Origination Form
Proposed Revisions to a Standard Plans Index

| Originator: | Stepp, Richard | Index Number: | 102-110 |
| E-mail: | richard.stepp@dot.state.fl.us | Index Title: | Type K Temporary Concrete Barrier System |

To accommodate newer Standard Plans options, "Single-Slope" traffic railing and concrete barrier shapes are being added as permanent barrier connection options throughout Index 102-110. Also, per a revision request from the State Materials Office, the word "fabric" is being removed from "geotextile" callouts.

CONNECTION TO PERMANENT RIGID BARRIER NOTES:
~~THRIE-BEAM GUARDRAIL SPLICE INSTALLATION NOTES:~~

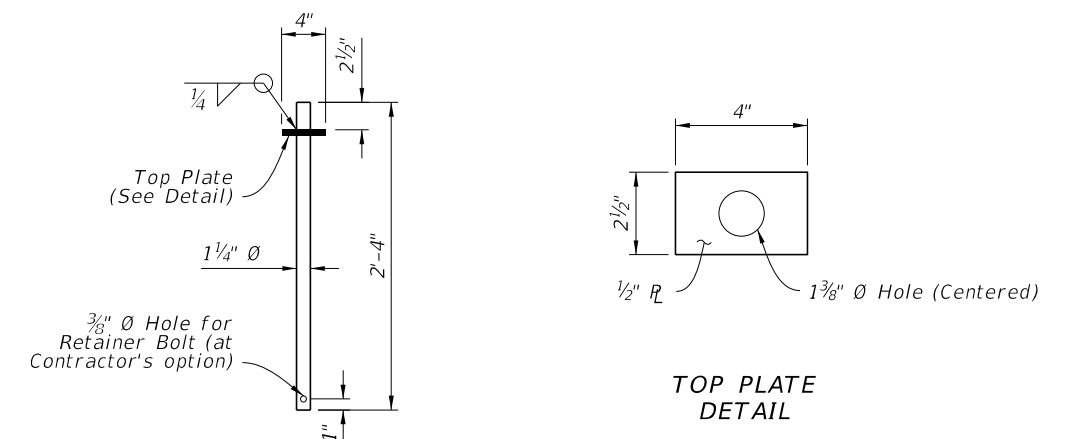
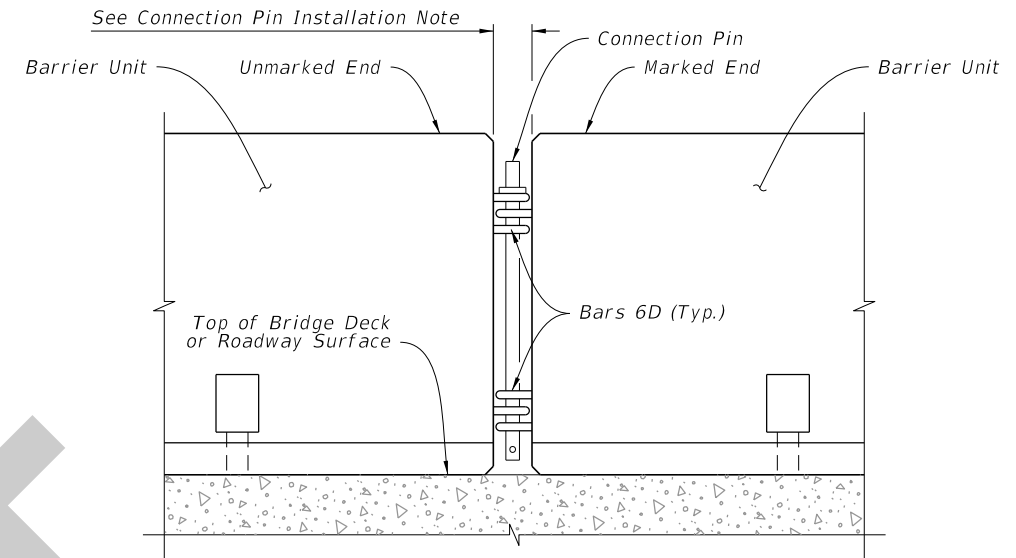
Sheet 1: General Notes - Rename "THRIE-BEAM GUARDRAIL SPLICE INSTALLATION NOTES" to "CONNECTION TO PERMANENT RIGID BARRIER NOTES". Added a new Note 1 to reference sheet numbers with splice connections and define barrier nomenclature. Incremented previous note numbers to account for the new Note 1;

1. For splice connection details between Type K Temporary Concrete Barriers and Permanent Traffic Railings, see Sheets 7 thru 10. Within this Index, the term Traffic Railing also applies to Concrete Barrier, where both terms refer to permanent installations shown in the Index 521 series.

TYPICAL SECTION
WITH SOIL BACK-FILL

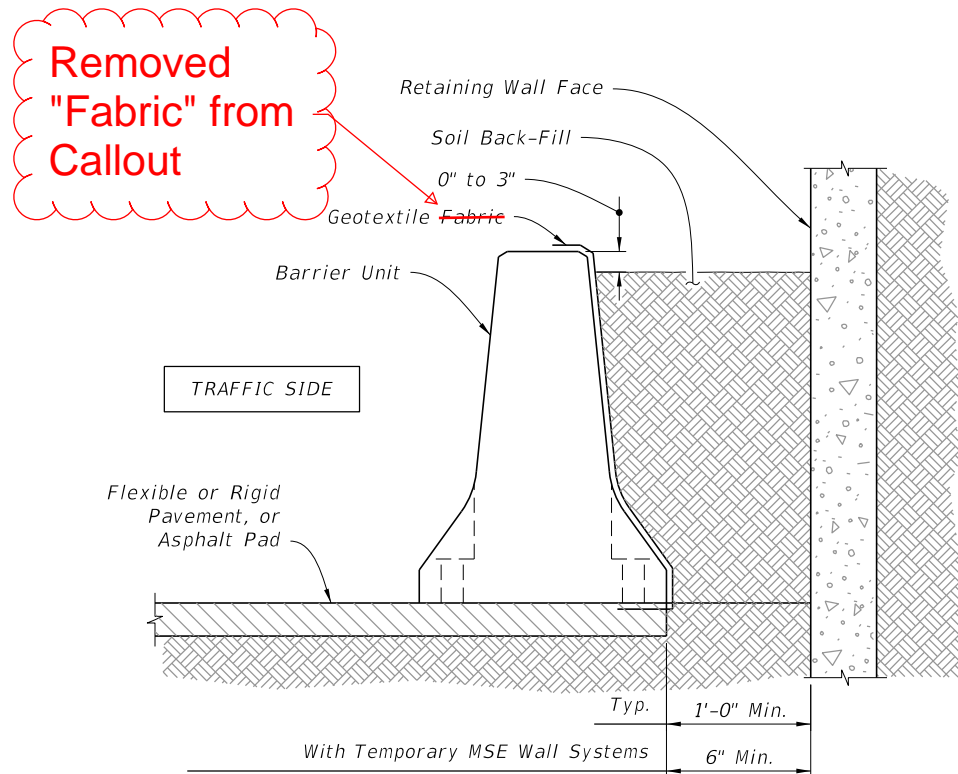
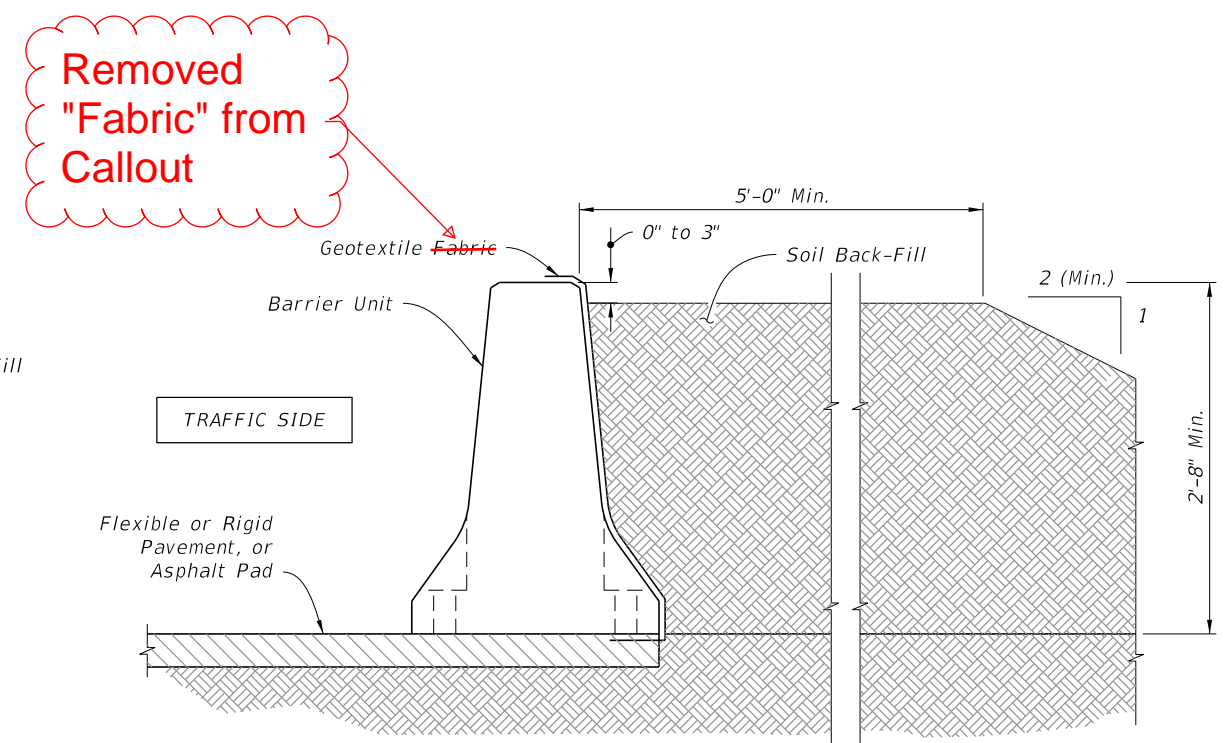
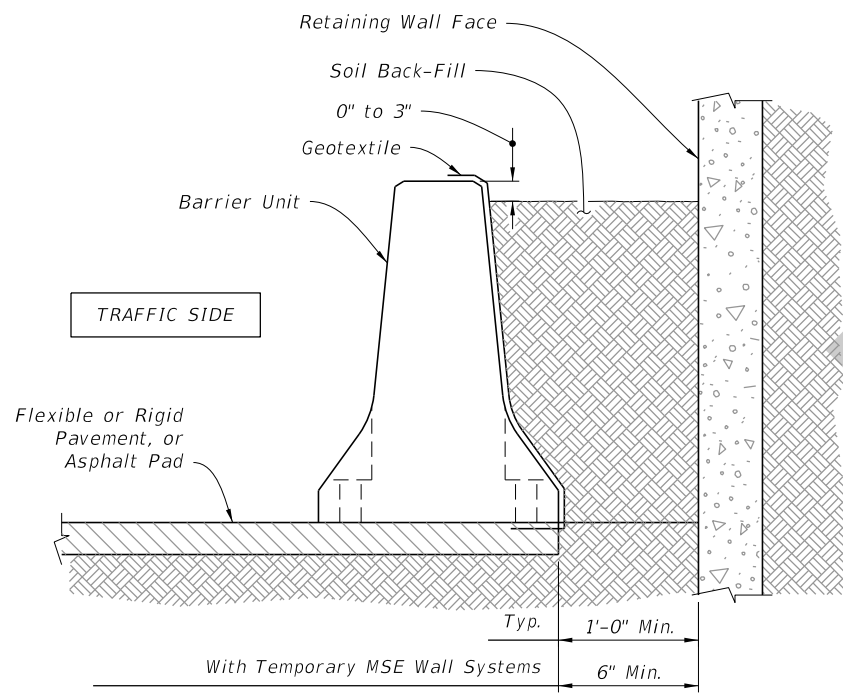
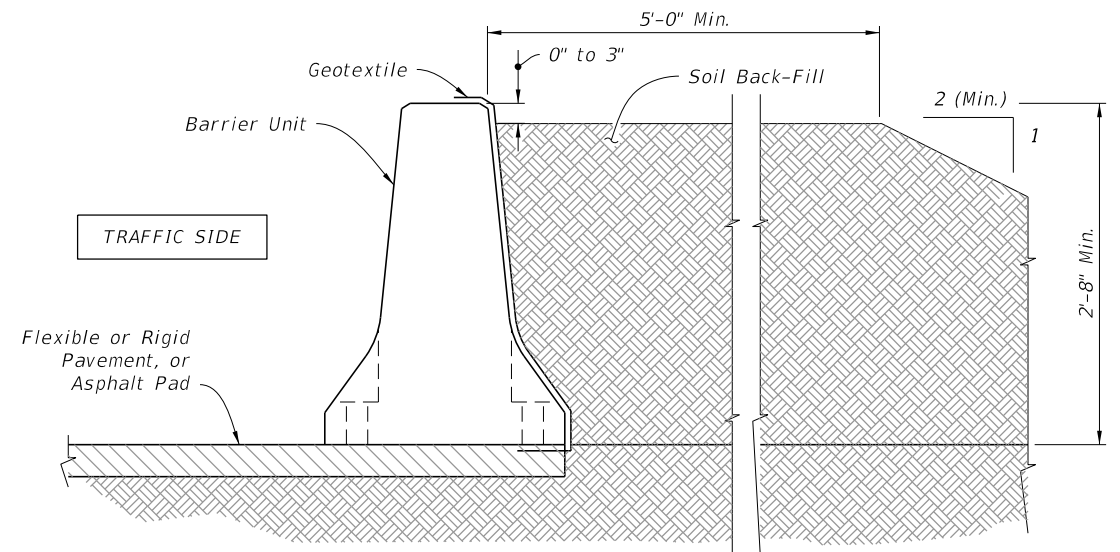
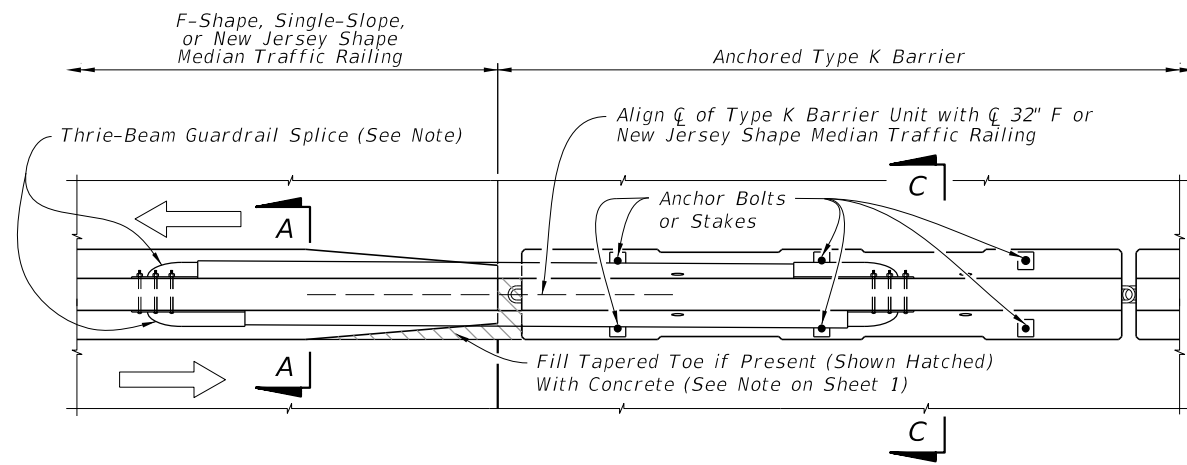
Sheet 4: Deleted "Fabric" from "Geotextile Fabric" callout on Typical Section details;

Removed "Fabric" from Callout

Removed "Fabric" from Callout

GEOTEXTILE: Provide and install Type D-5 geotextile in accordance with Specification 514 to contain Back-Fill Material behind the Barrier Units. Geotextile may be continuous over the length and height of the installation or may be individual pieces as required to cover the Lift/DrainSlots and open vertical joints between Barrier Units.

PARTIAL PLAN VIEW AT MEDIAN TRAFFIC RAILING

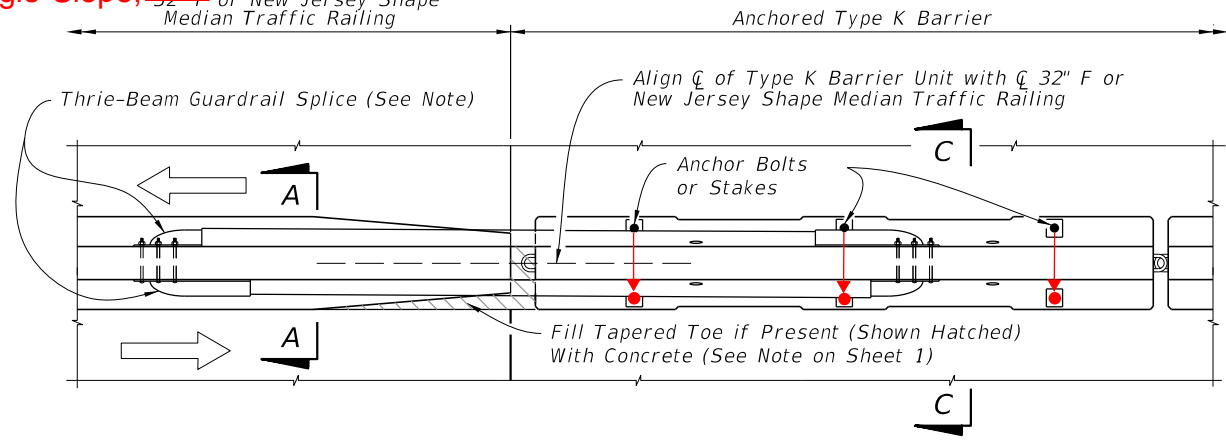
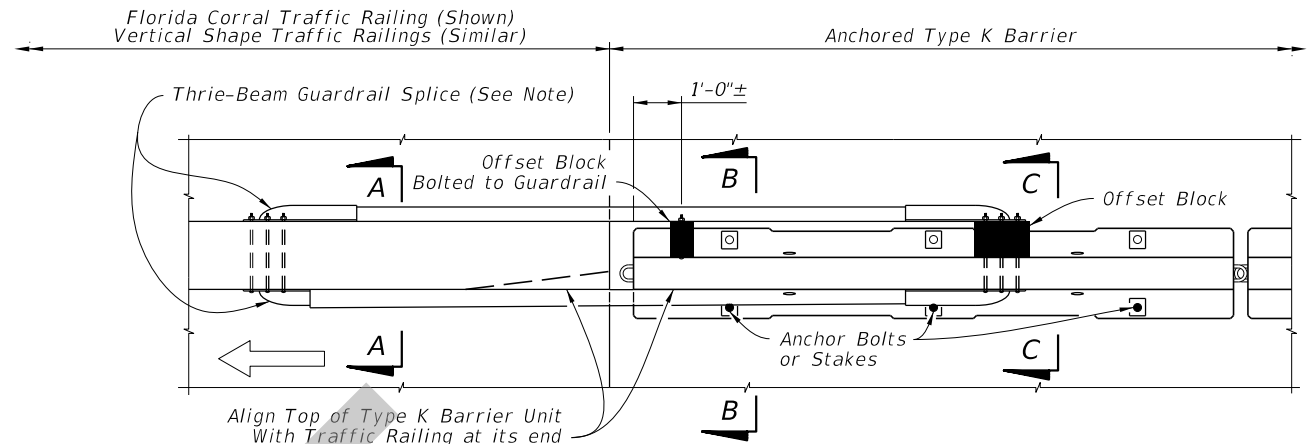
Sheet 7: In the Partial Plan View at Median Traffic Raining, added anchor call outs on both sides of the barrier for consistency with Sheet 6;

F-Shape, Single-Slope, ~~32" F or New Jersey Shape~~ Median Traffic Railing

PARTIAL PLAN VIEW AT MEDIAN TRAFFIC RAILING

For Single-Slope, F-Shape, APPROACH TRANSITION SPLICE DETAIL FOR F AND NEW JERSEY SHAPE TRAFFIC RAILINGS AND 8' & 14' TRAFFIC RAILING / NOISE WALLS (CONCRETE BARRIER WALL SIMILAR)

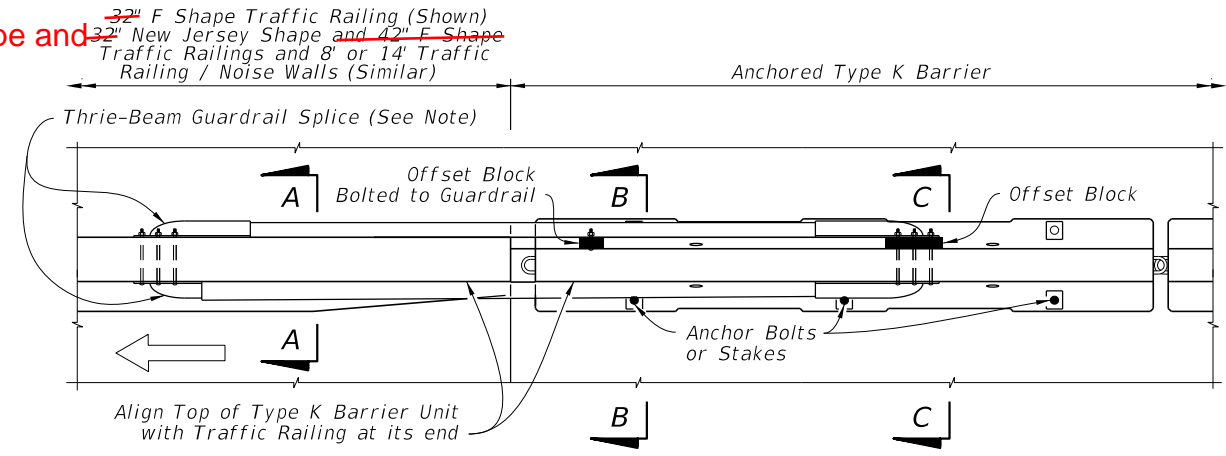
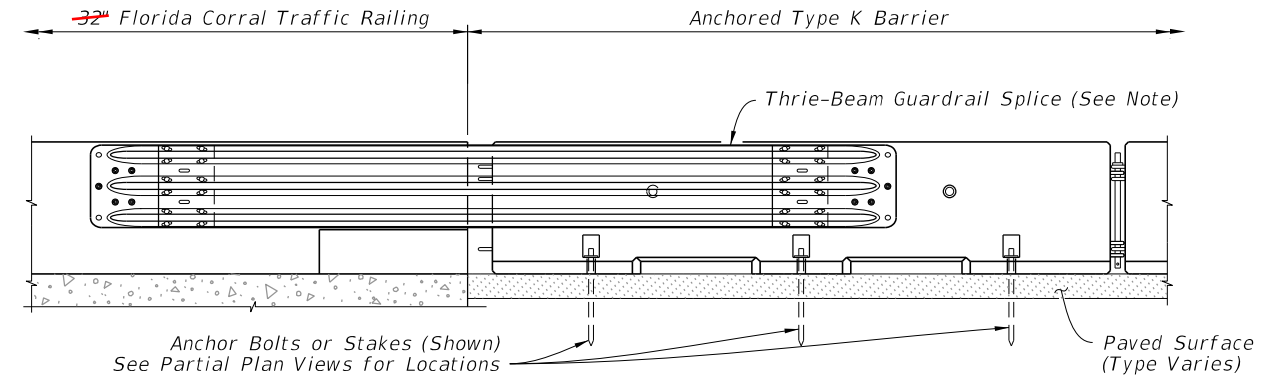
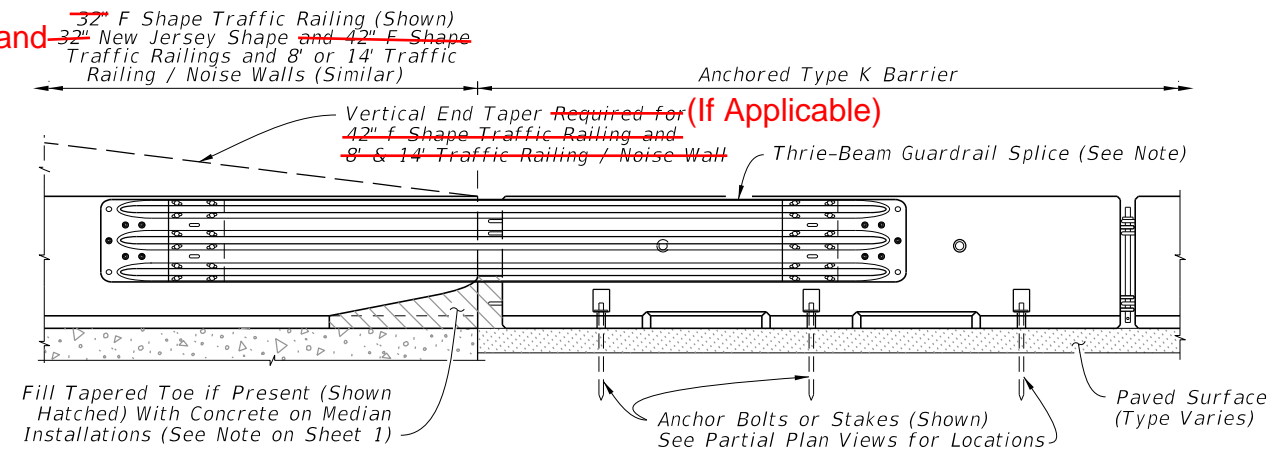
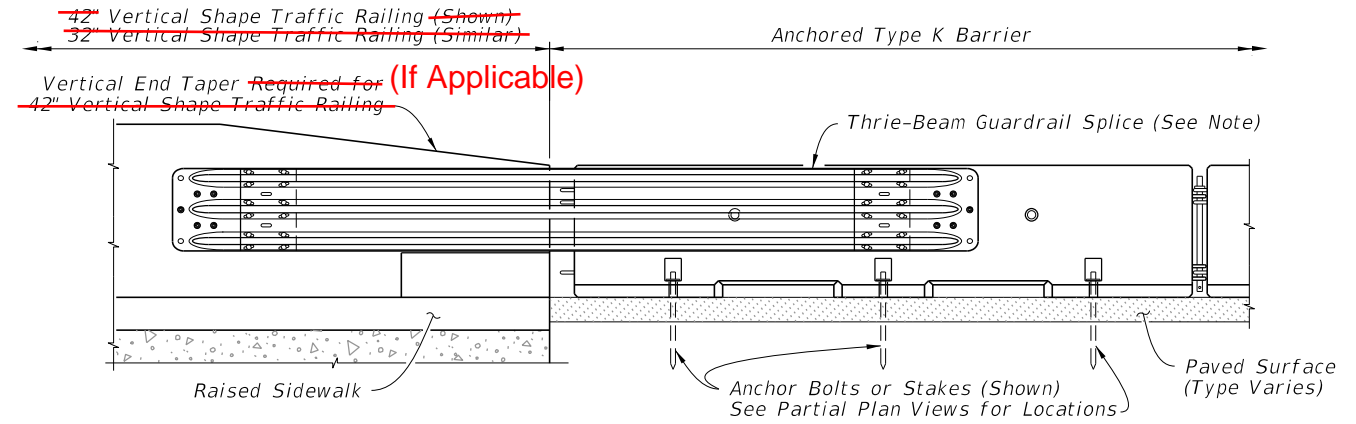
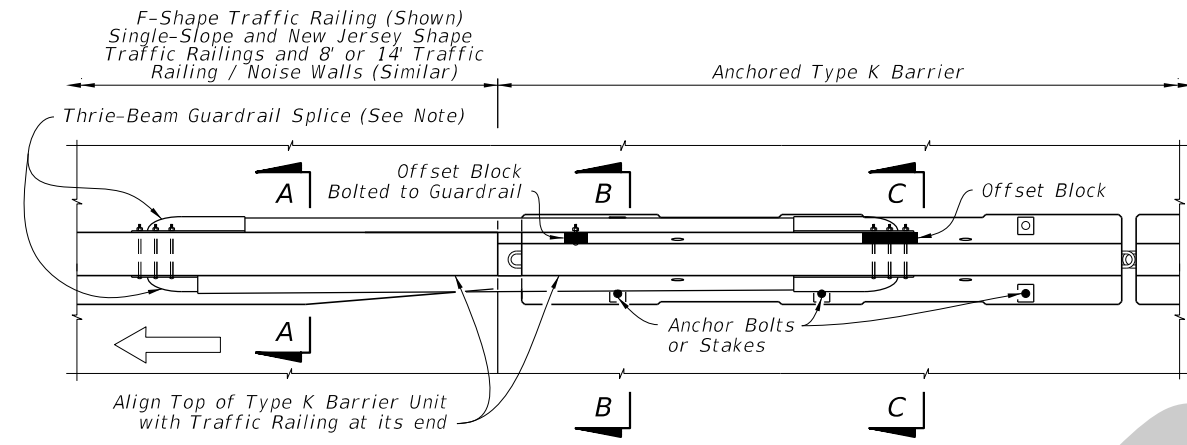
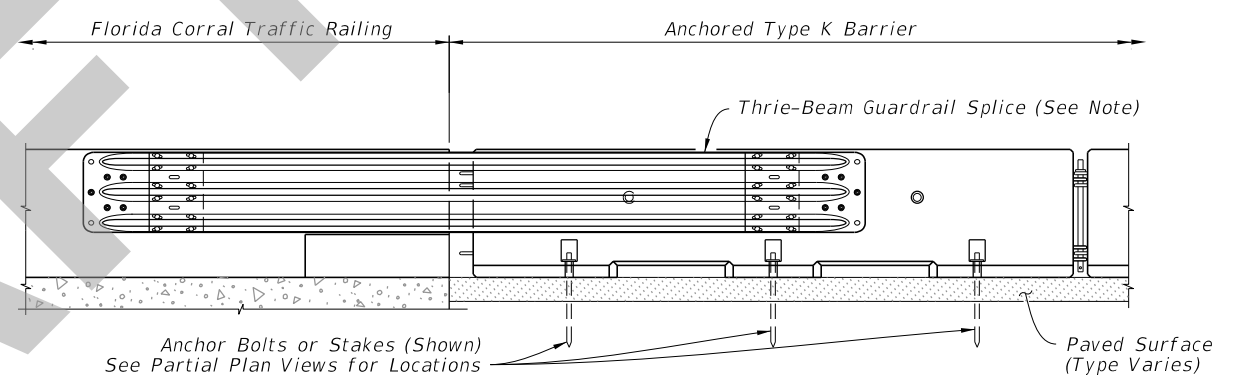
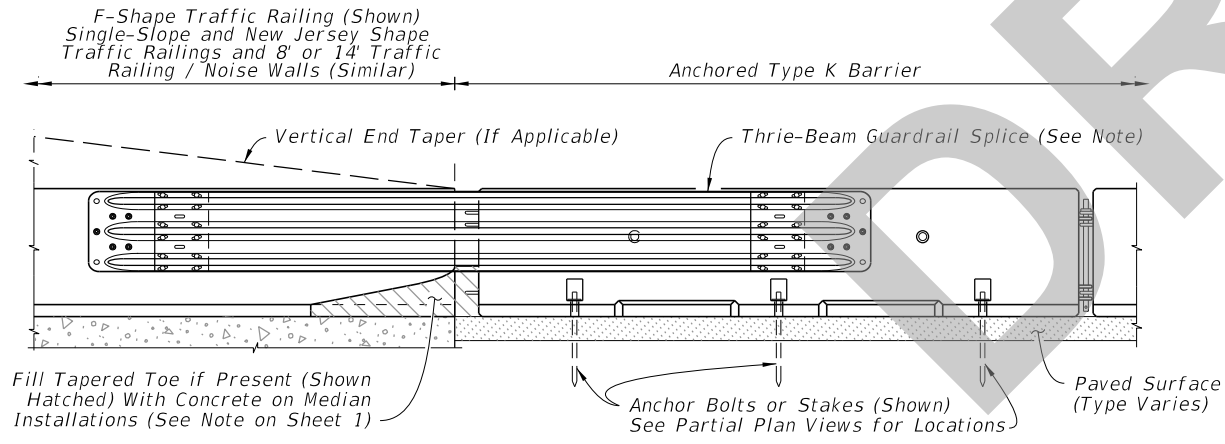
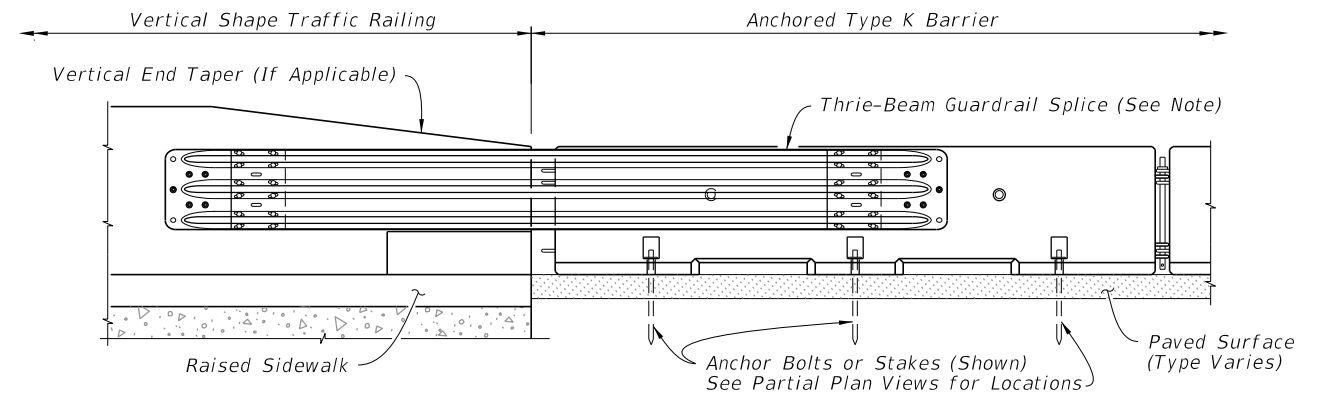
Sheets 7-10: Revised detail labels to simplify and include "Single-Slope" Traffic Railings and Concrete Barriers where applicable

Single-Slope and ~~32" F Shape Traffic Railing (Shown)~~ / ~~32" New Jersey Shape and 42" F Shape Traffic Railings and 8' or 14' Traffic Railing / Noise Walls (Similar)~~

Single-Slope and ~~32" F Shape Traffic Railing (Shown)~~ / ~~32" New Jersey Shape and 42" F Shape Traffic Railings and 8' or 14' Traffic Railing / Noise Walls (Similar)~~

APPROACH TRANSITION SPLICE DETAIL FOR SINGLE-SLOPE, F-SHAPE, AND NEW JERSEY SHAPE TRAFFIC RAILINGS AND 8' & 14' TRAFFIC RAILING / NOISE WALLS (CONCRETE BARRIER SIMILAR)
